PUBLIC INTEREST TECHNICAL REVIEW FOR GROUNDWATER APPLICATIONS

TO: Water Rights Section Date: 5/1/2026
FROM: Groundwater Section Joe Kemper
Reviewer's Name
SUBJECT: Application LL- 2023 Supersedes review of NA

Applicant's Name: Knife River Corporation Northwest County: Crook
Applicant(s) seek(s) 1.11 cfs from 1 well(s) in the Deschutes Basin,
Lower Crooked subbasin

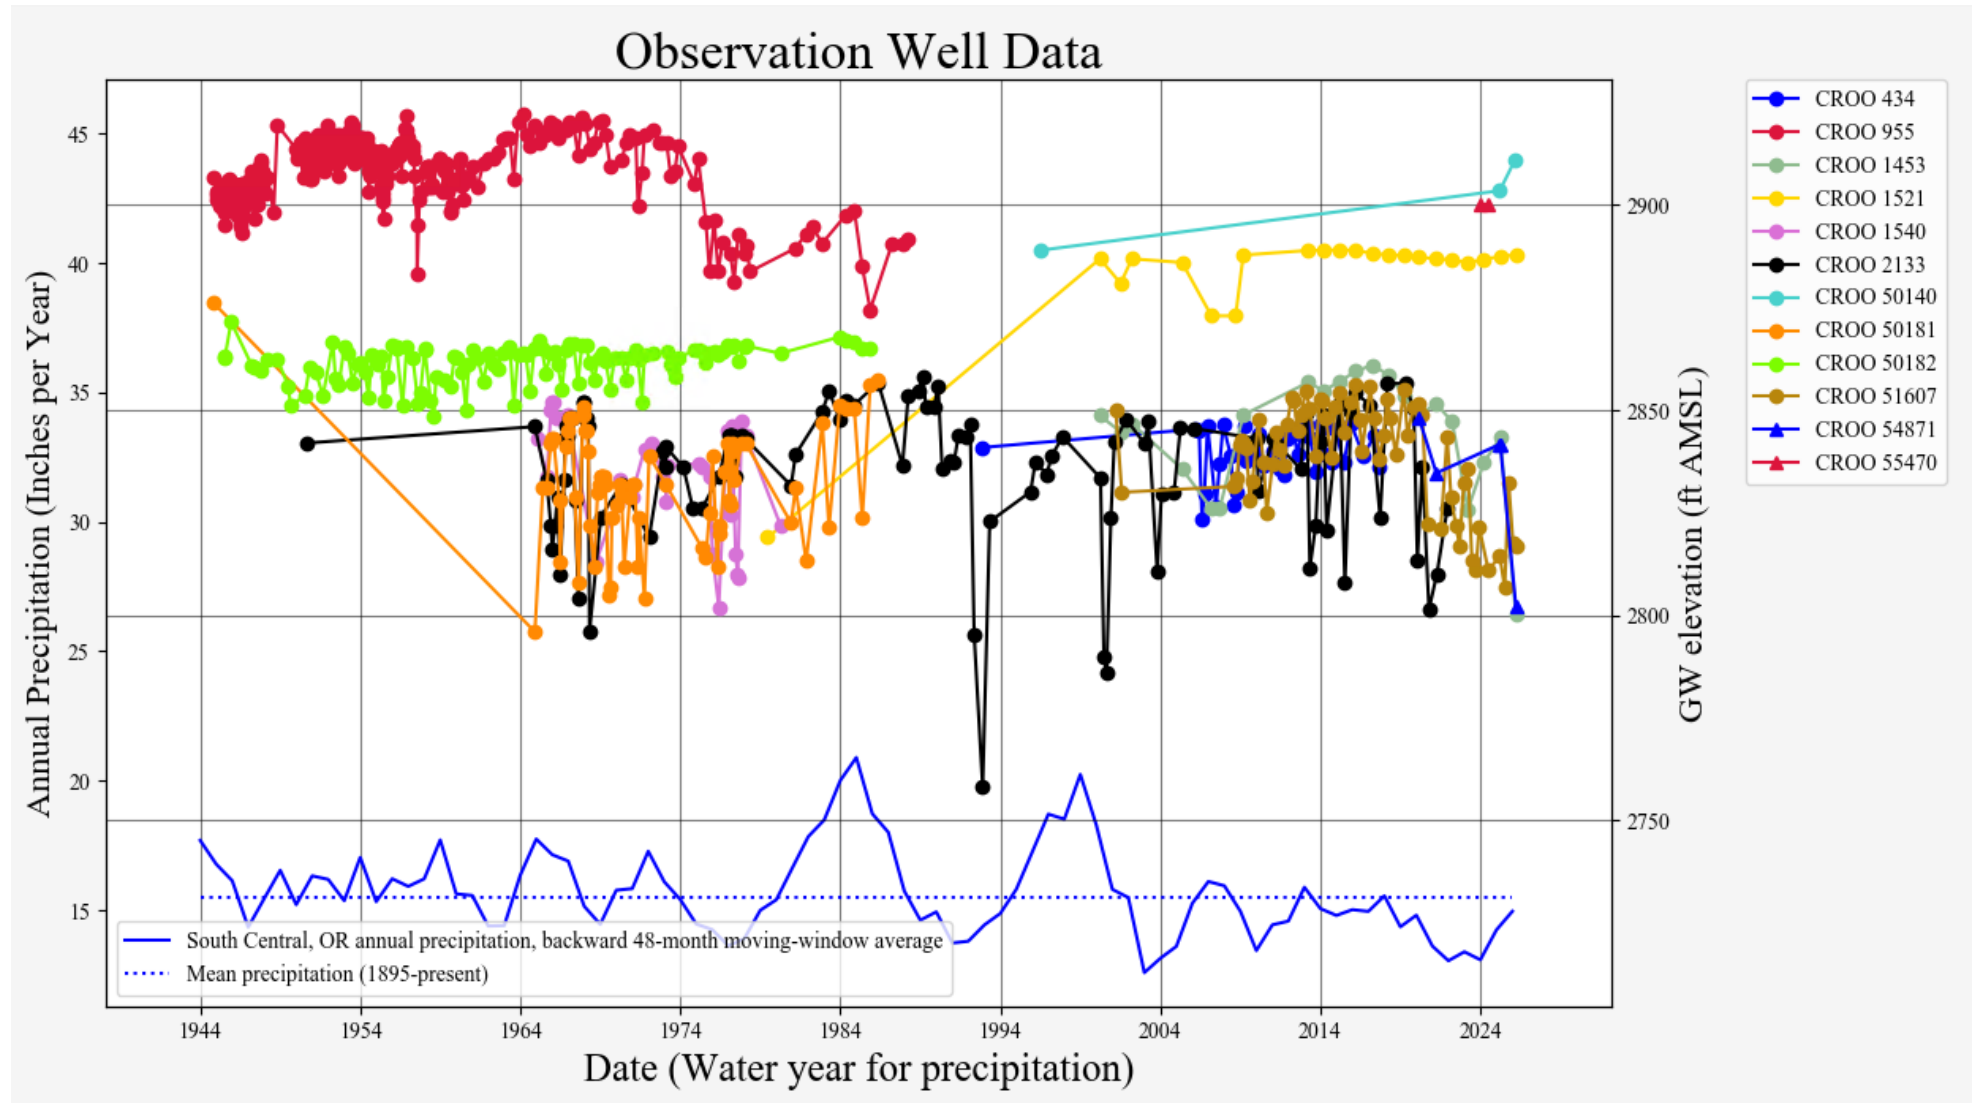
Comments: Wells in the target aquifer near Prineville (e.g., CROO 54871, CROO 1453) and McKay Creek (CROO 51607) are not reasonably stable. The older record from CROO 955 (0.7 miles away) suggests that the target aquifer exhibits a similar pattern to the McKay Creek and Prineville wells. CROO 1521 accesses the target aquifer and shows a stable trend; however, the preponderance of evidence indicates that the target aquifer does not have reasonably stable water levels. Additional time-series water-level data from the applicant's well or nearby wells could modify this finding.

Hydrograph 2. Reasonably Stable Groundwater Level findings for Representative Wells

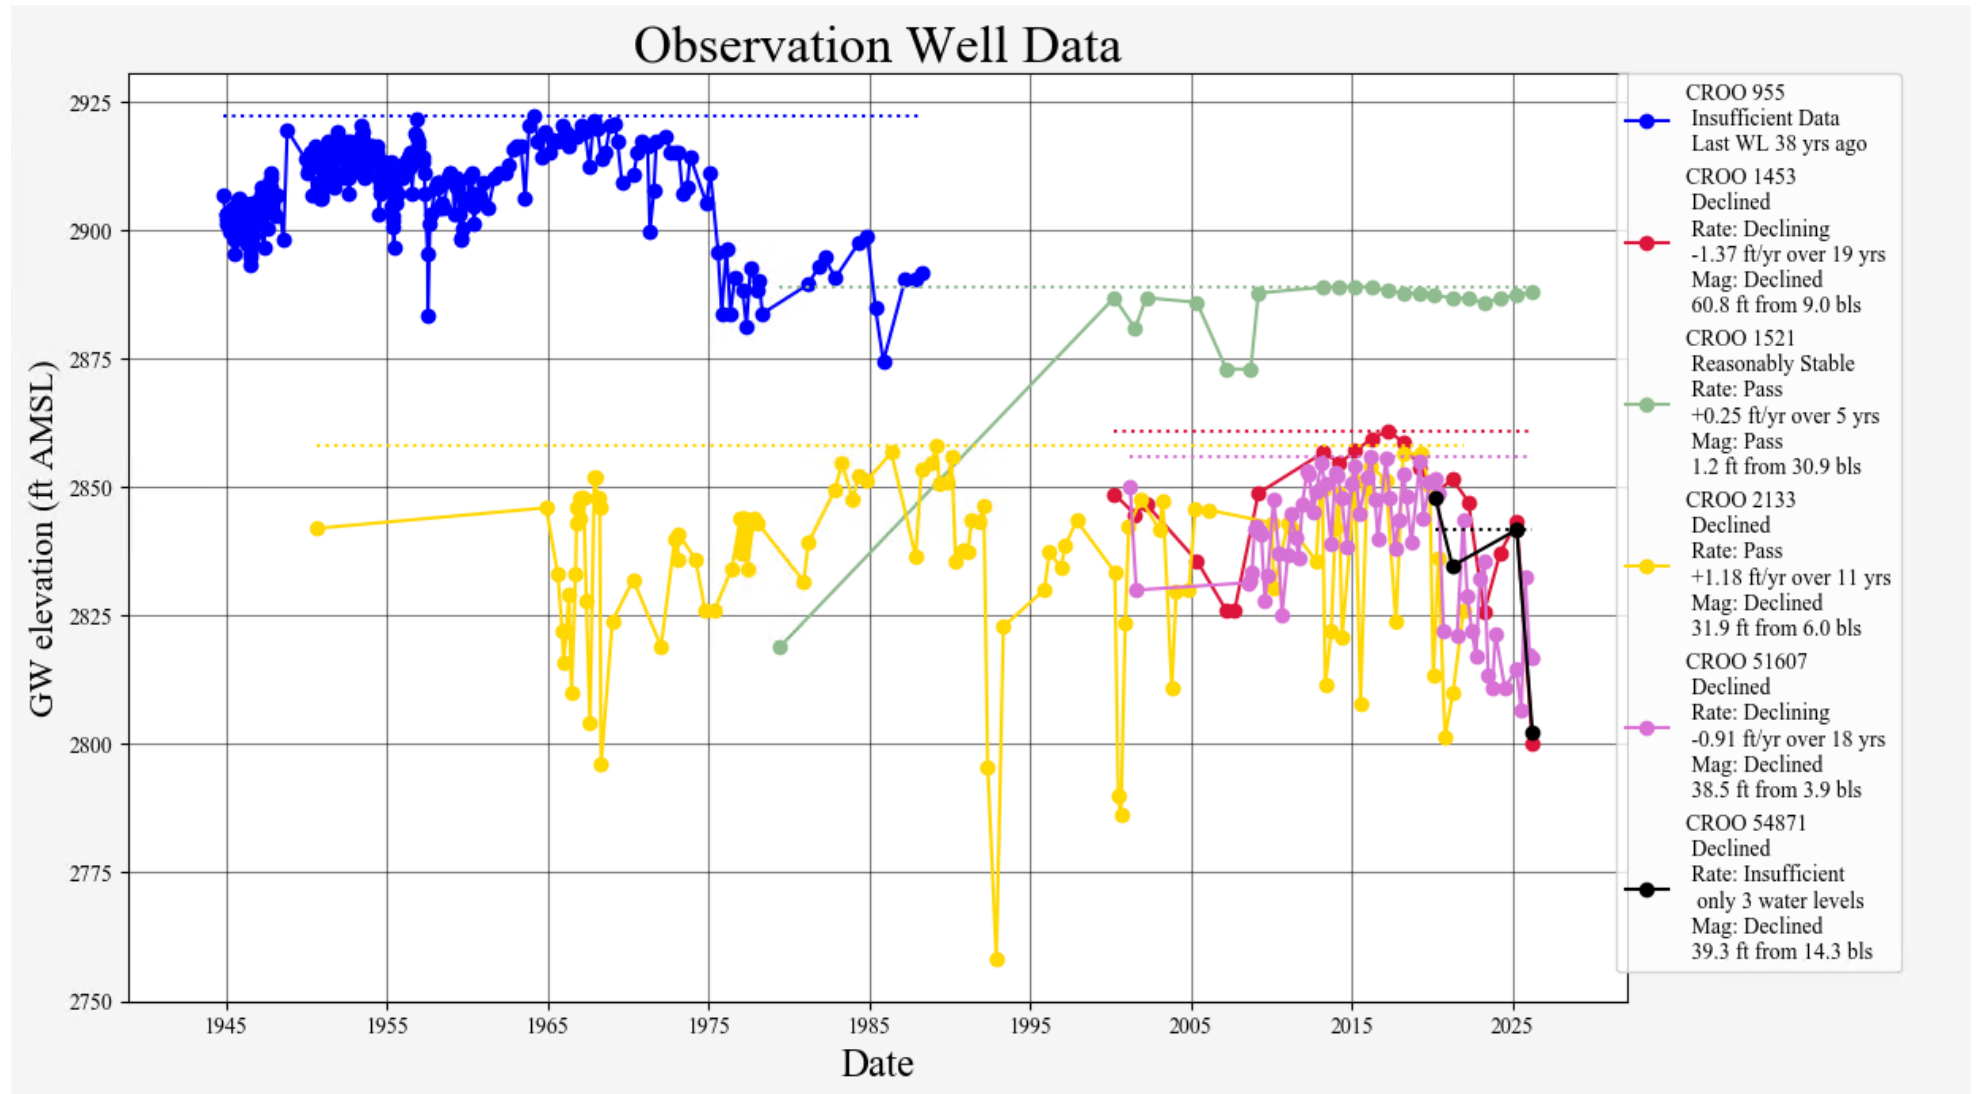
Well Log ID	POA Well #	Reference Level for Evaluation of Reasonable Stability (ft bls)	Rate Test	Magnitude Test	Water Levels Reasonably Stable
CROO 51607	N/A	3.94	Fail	Fail	Declined or Declining
CROO 1453	N/A	9	Fail	Fail	Declined or Declining
CROO 1521	N/A	30.9	Pass	Pass	Reasonably Stable
CROO 2133	N/A	6	Pass	Fail	Declined or Declining

Comments: See hydrographs below.
